UNITED STATES PATENT AND TRADEMARK OFFICE

APPLICATION NO.	FILING DATE	FIRST NAMED INVENTOR	ATTORNEY DOCKET NO.	CONFIRMATION NO.
09/600,832	07/21/2000	ANDREAS GIEFER	67526	2069

Office Action Summary

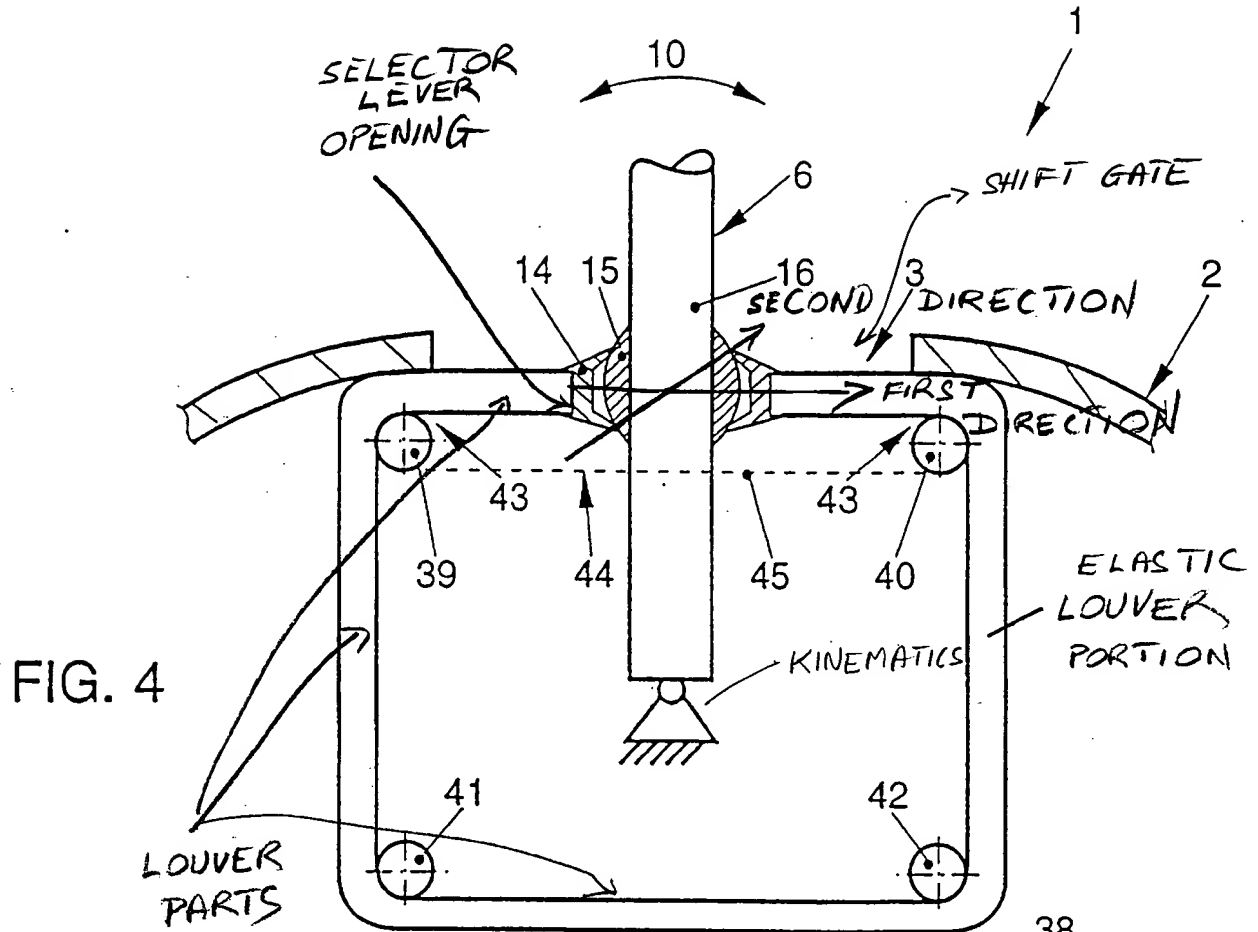
Regarding claims 18 and 31, Figs. 4-7 of Andronis teaches a motor vehicle transmission shifting device slot cover, the shifting device having a selector lever 6, 16 and kinematics for

transmitting the selection movements to a transmission and at least one shift gate (at 3 in Fig. 4, see Exhibit attached), the slot cover comprising:

- a movable louver 3 which covers the at least one shift gate, said louver 3 having at least one opening (see Exhibit attached) for the passage of the selector lever 6, 16, said louver 3 being an endless band forming a closed loop (Fig. 4);

Regarding claim 24, said deflecting element 39-42 is arranged within said louver closed loop 3 (Fig. 4).

Regarding claim 27, said louver 3 comprises an elastic louver portion (see the vertical portion in the Exhibit) having elastic properties, at least in the circumferential direction of the closed loop, said elastic louver portion being provided over at least a part of a length of said louver.

Regarding claim 28, said louver 3 comprises a plurality of parts (i.e., horizontal and vertical parts in Fig. 4 of the Exhibit).

a louver 3 movably connected to said louver guide 14, 15, 38-46 in a first direction (which is the first sideway direction of the pivotal movement/displacement of the lever 6 in Fig. 4), said louver 3 including an endless band 3 forming a closed loop, said louver defining a selector lever opening (see Exhibit);

a cover plate 2, said louver guide 14, 15, 38-46 being movably connected to said cover plate 2 in a second direction (which is the second sideway direction of the pivotal movement/displacement of the lever 6 in Fig. 4 as seen in Exhibit), said second direction being substantially perpendicular to said first direction.

FIG. 6

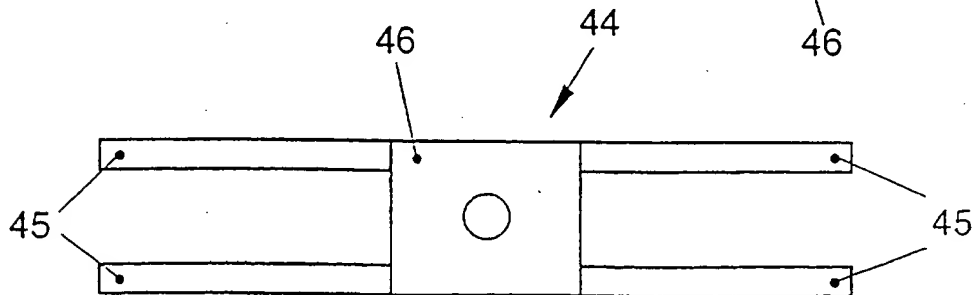
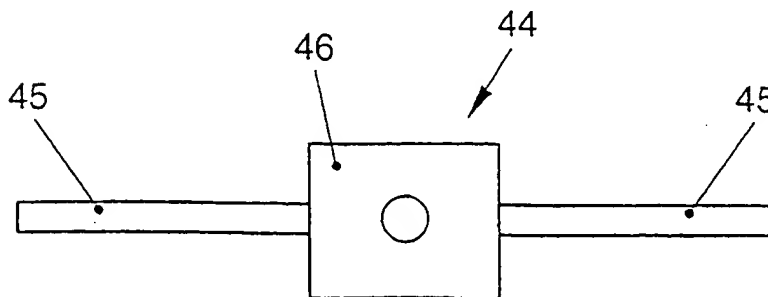
Regarding claim 29, said louver guide 14, 15, 38-46 includes a support structure 44 with slide rails 45 (Fig. 6) arranged laterally and engaged by said louver 3 for guiding said louver 3.
